Cross River Rail project

Coordinator-General's change report – design refinements and condition changes 2020

July 2020

Figure 4.7 Permanent and temporary land requirement at Lanham Street, Bowen Hills and Brisbane Exhibition showgrounds

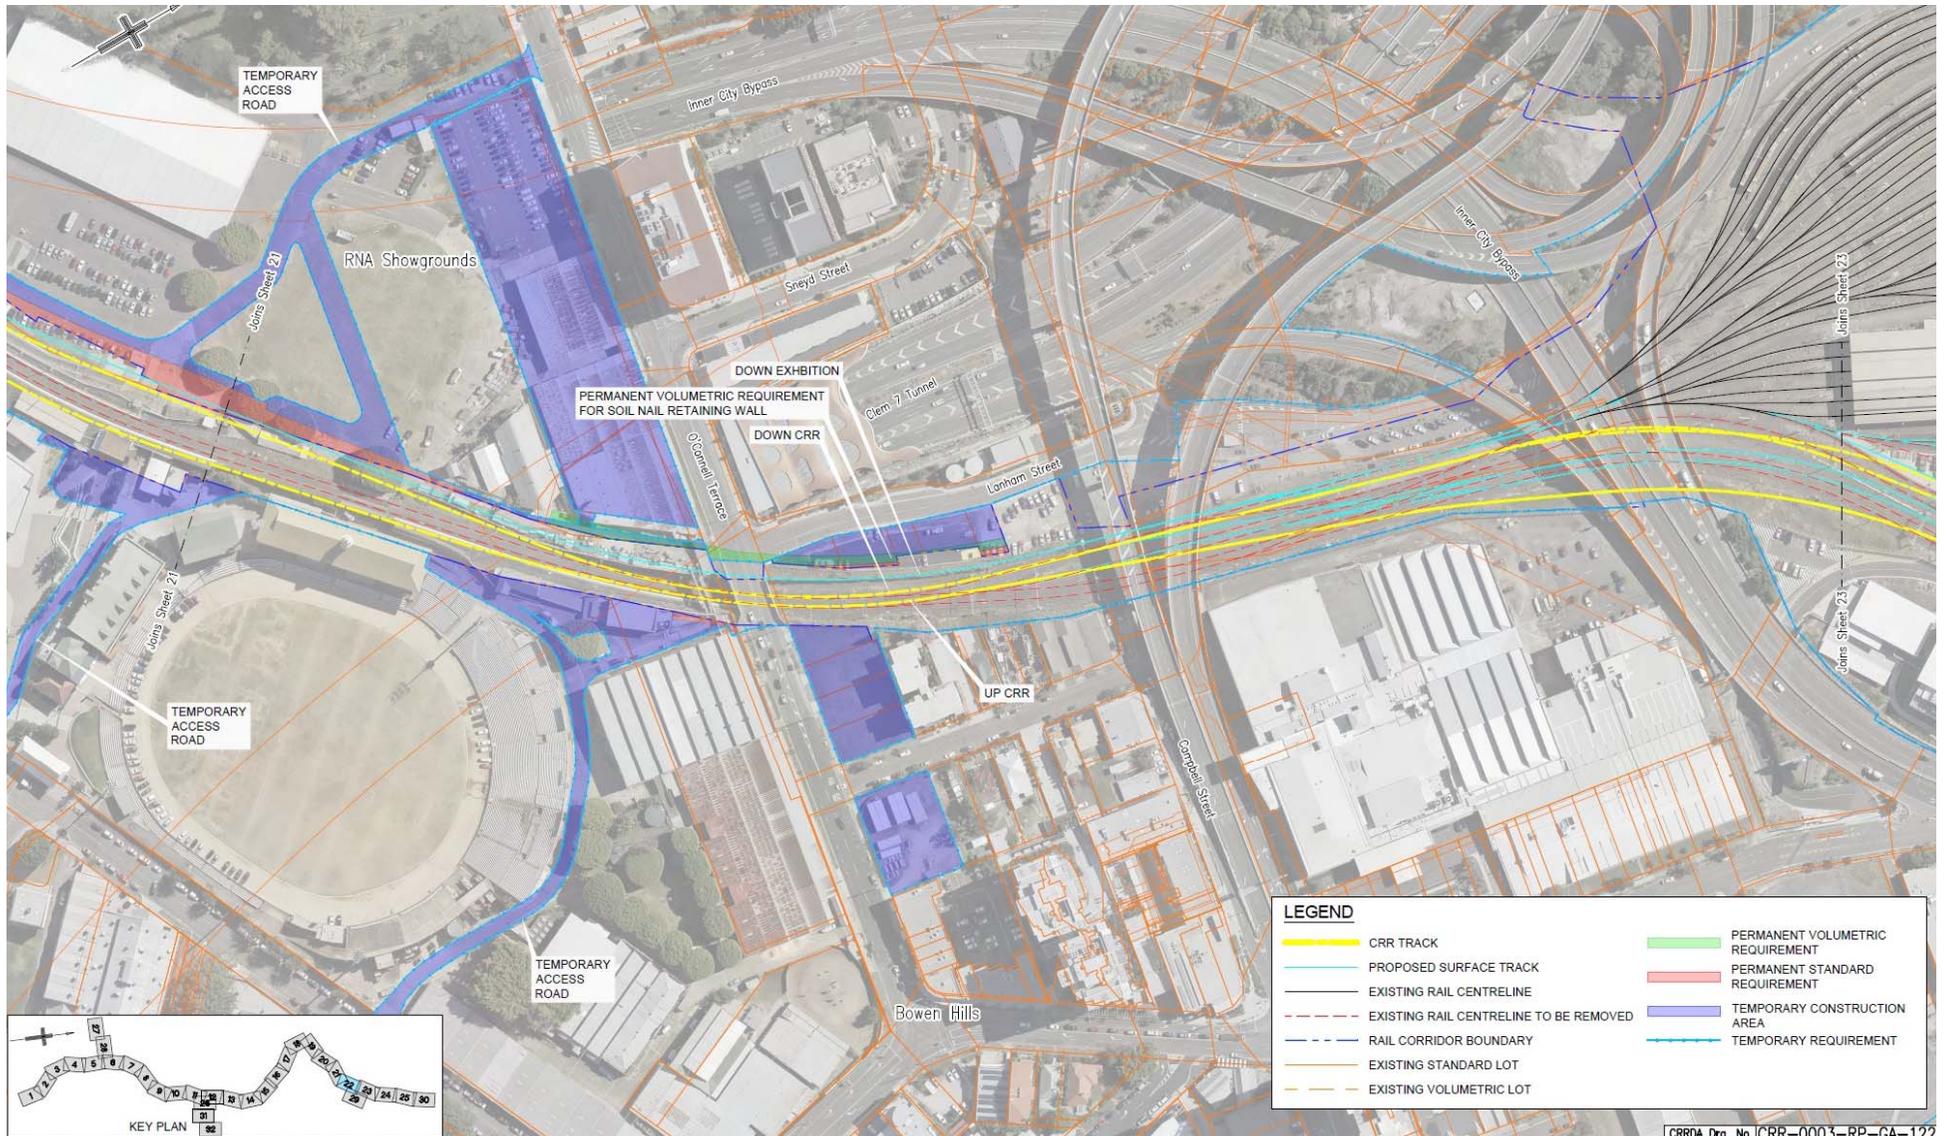
A change to the project's approved land requirements at Lanham Street, Bowen Hills has been requested to accommodate design refinements and change to the construction methodology required for the widening of the rail corridor in this location. The change will result in a permanent requirement for additional surface and volumetric land across multiple lots (see Figure 4.7).

As stated in the proponent's project change application, the rail corridor widening works and the associated impacts for the rock cutting embankment are not new works and have been approved as part of the previously evaluated project. The only change to the project is the volumetric land requirement across multiple lots to accommodate the soil nails into the retaining wall, and the required update to the project's approved boundary.

I approve the proposed change of a partial volumetric and surface requirement across multiple lots at Lanham Street, and I am satisfied that consultation with affected landowners in relation to these proposed works has been undertaken.

Figure 4.8 Proposed temporary land requirements at Brisbane Exhibition Showground

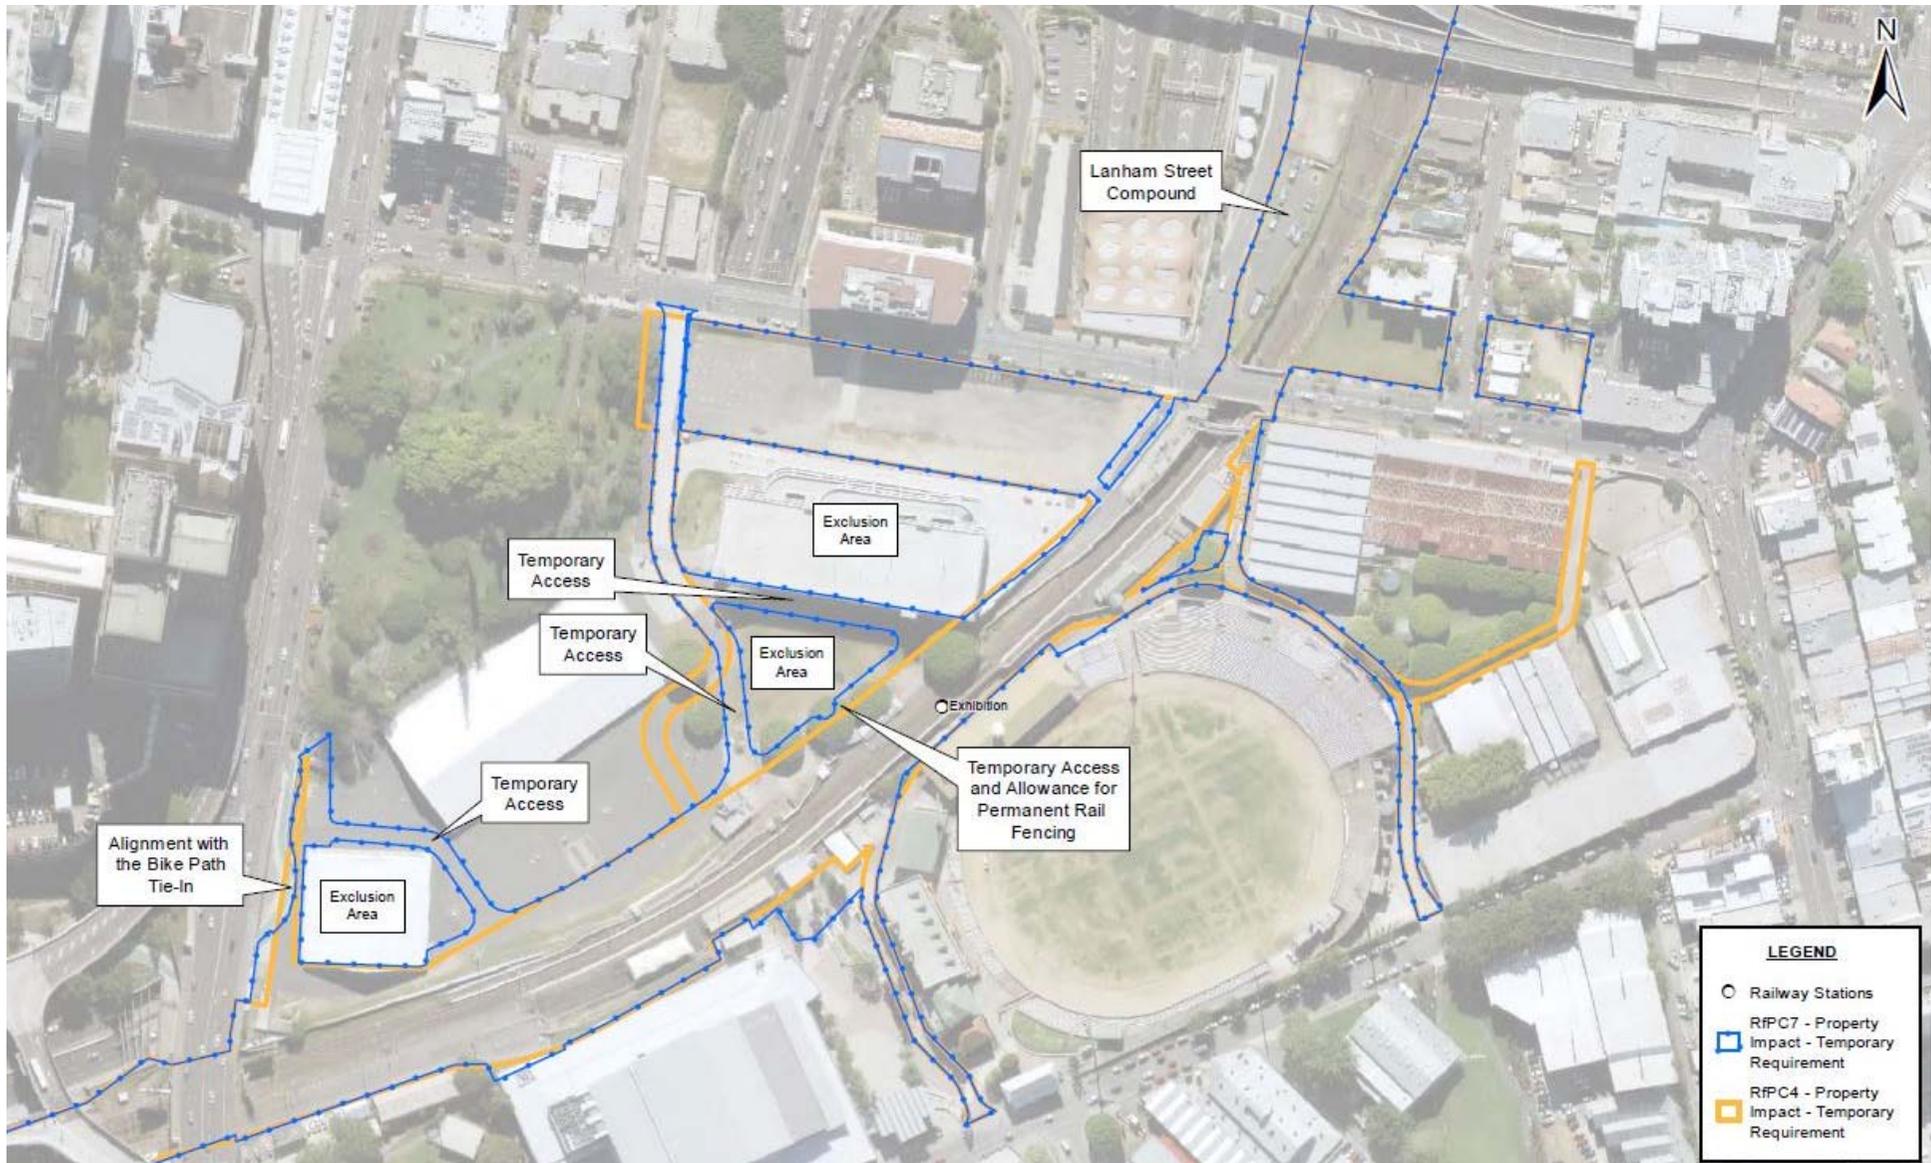
The proponent has requested changes to the temporary land requirements for construction access and worksites at Exhibition station. Increased permanent surface land requirements across multiple lots to accommodate further design refinements have also been requested. Figure 4.7 shows the location of the permanent surface requirements and Figure 4.8 shows the location of changes in temporary land requirements.

I have considered the proposed changes for Exhibition station and I am satisfied that the project's environmental management framework consisting of the Imposed Conditions, the OEMP and CEMP are sufficient to manage the environmental impacts. I accept the proposed change to both temporary and permanent land requirements for the construction of Exhibition station.
